ADDENDUM NO. 1
CLASSROOM ADDITION TO ELVIN HILL ELEMENTARY SCHOOL
Architect Job No. 25-34
December 2, 2025
DCM #2025854

The Plans and Specifications are hereby amended. The following supersedes all contrary and/or conflicting information and is made part of the contract documents.

1 FLOOR PLAN ADDITION/ALTERNATE

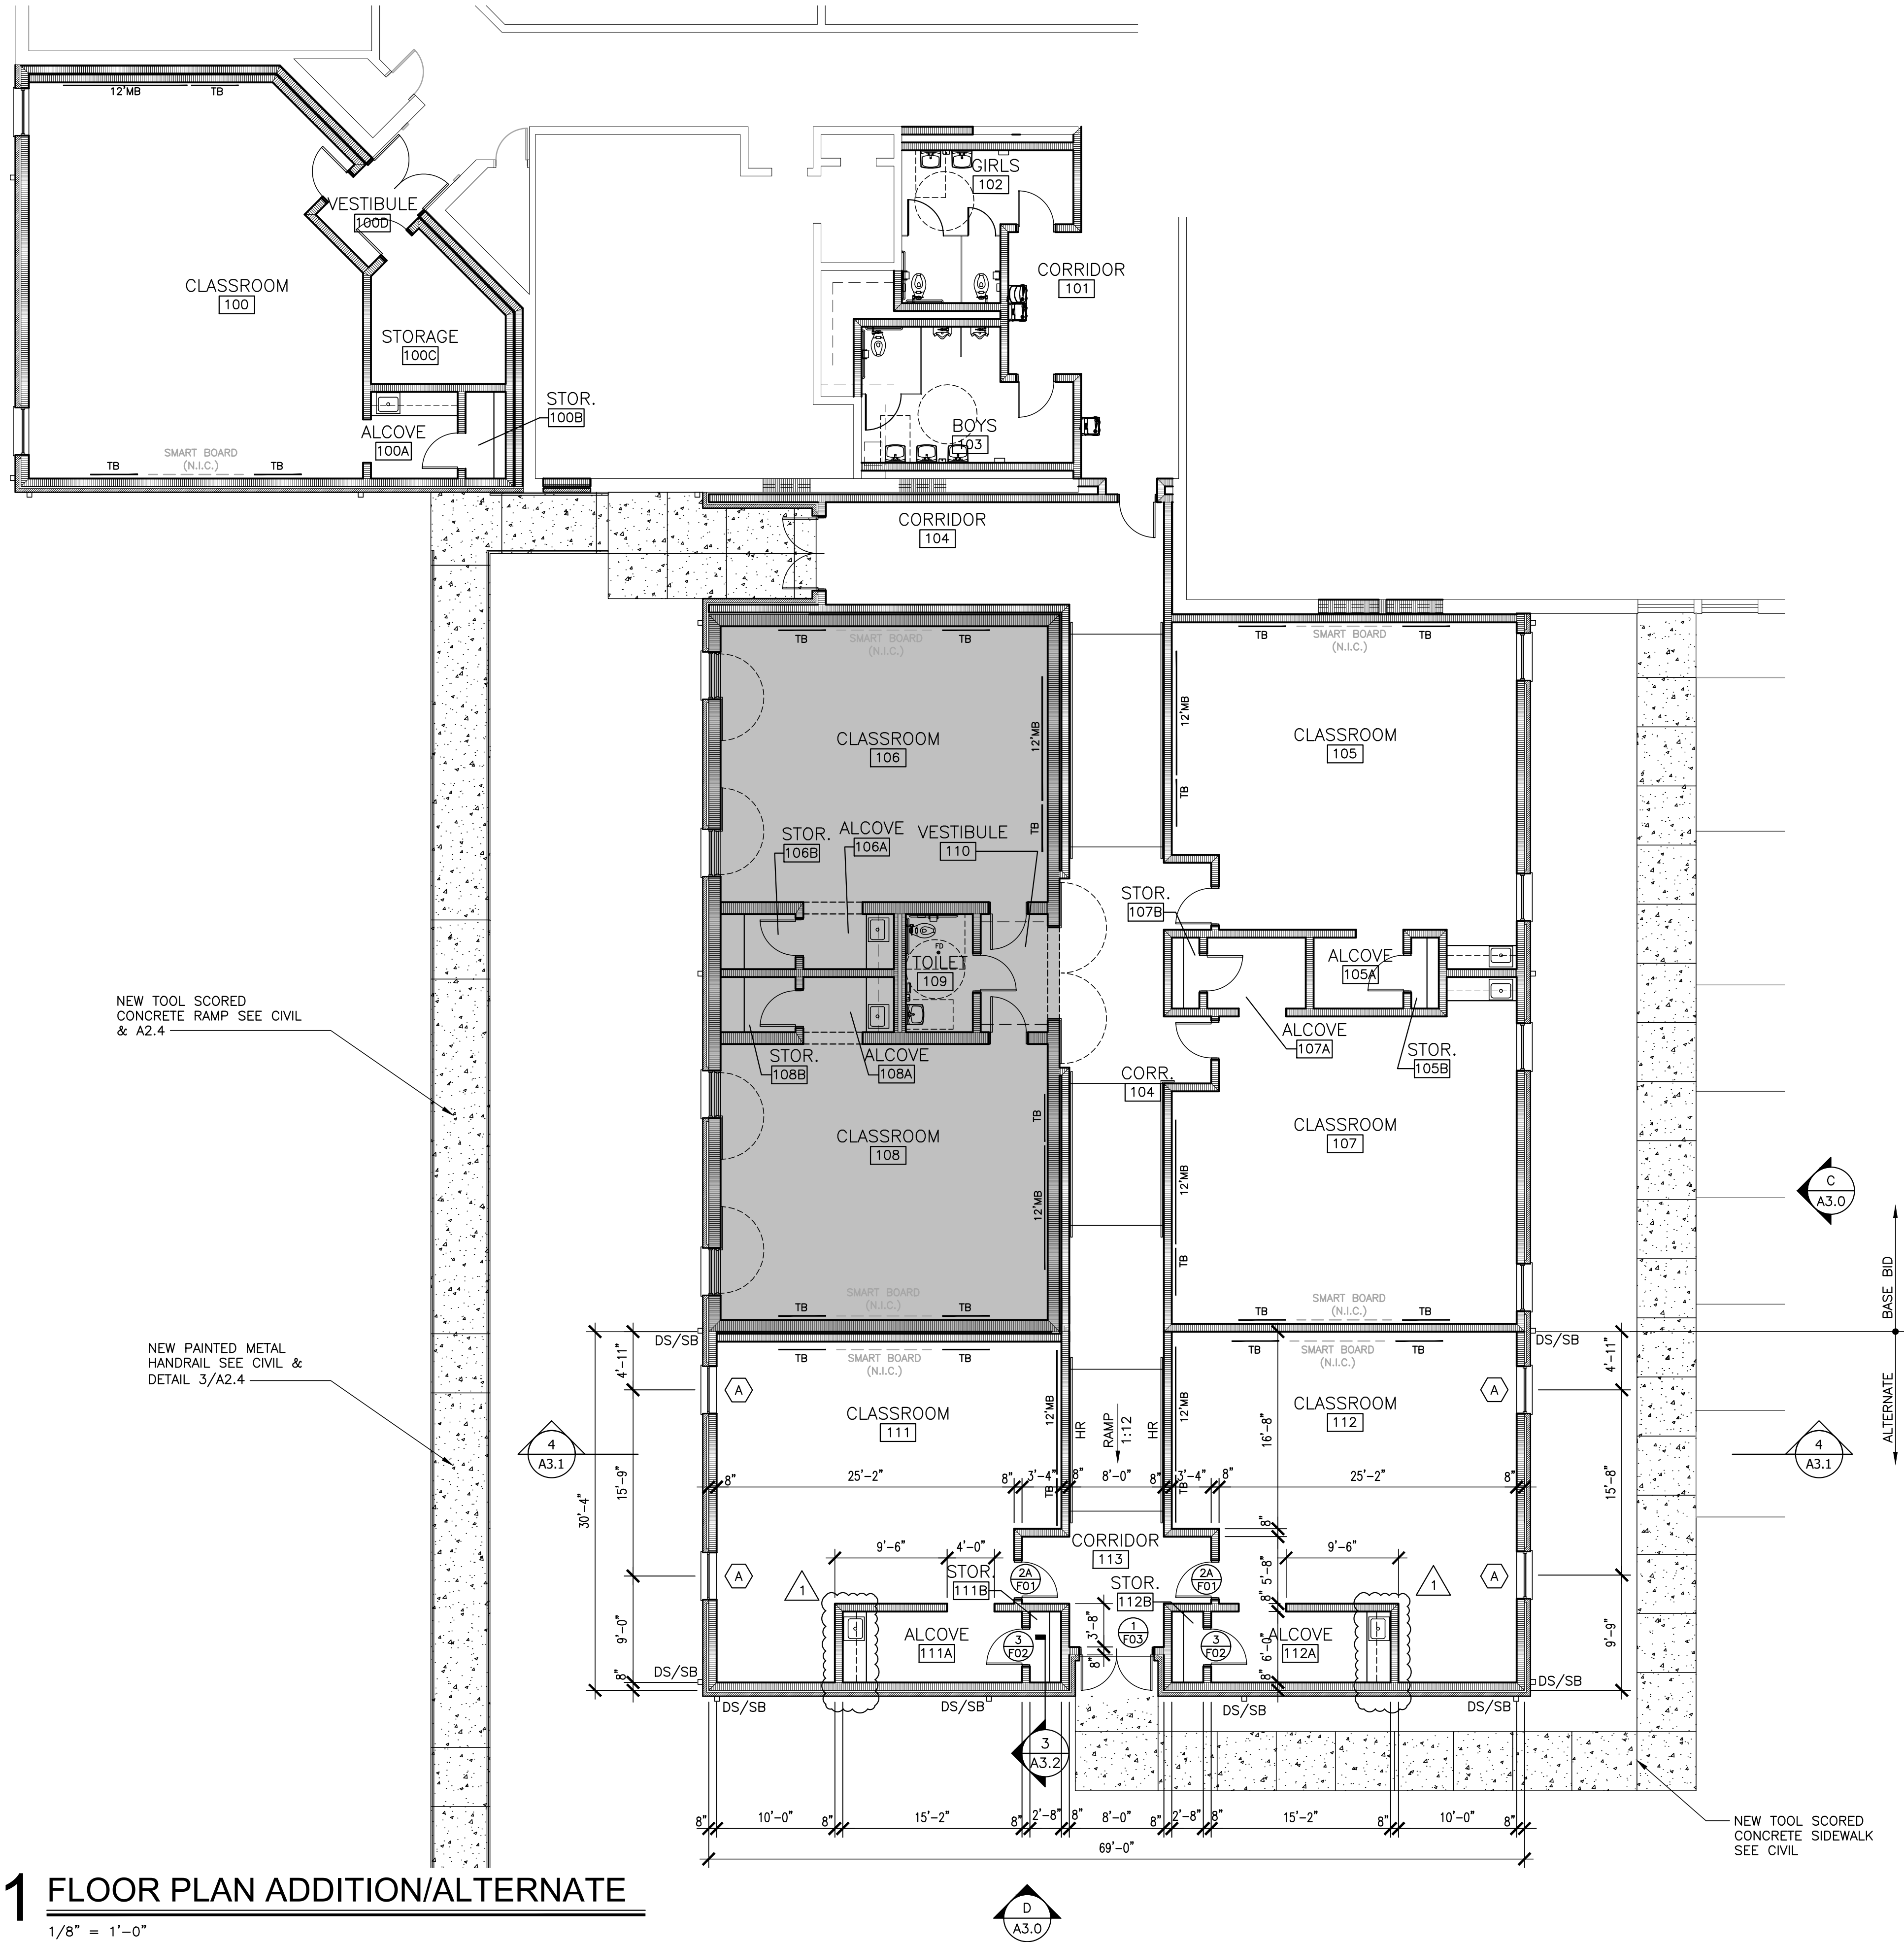
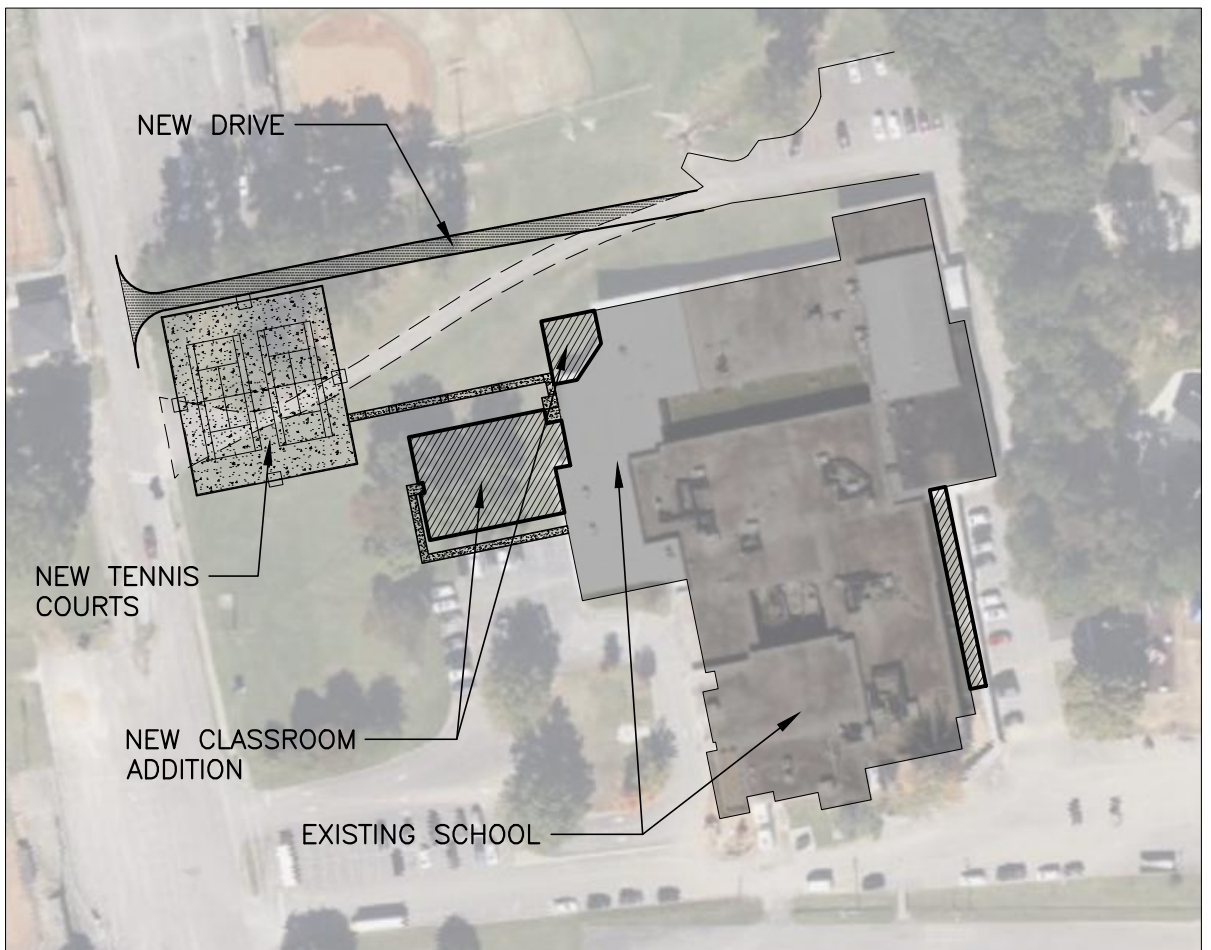
1. **Sheet A2.0.1** – Floor Plan Additional Alternate: See clouded for revisions.
2. **Sheet A10.0** – Plans and Details – Berm Removal & New Brick Facade: See clouded for revisions.
3. **Sheet M0.2** – Mechanical Schedules: See clouded for revisions.
4. **Sheet M0.5** – Mechanical Calculations and Controls: See clouded for revisions.
5. **Sheet M0.6** – Mechanical Controls: See clouded for revisions.
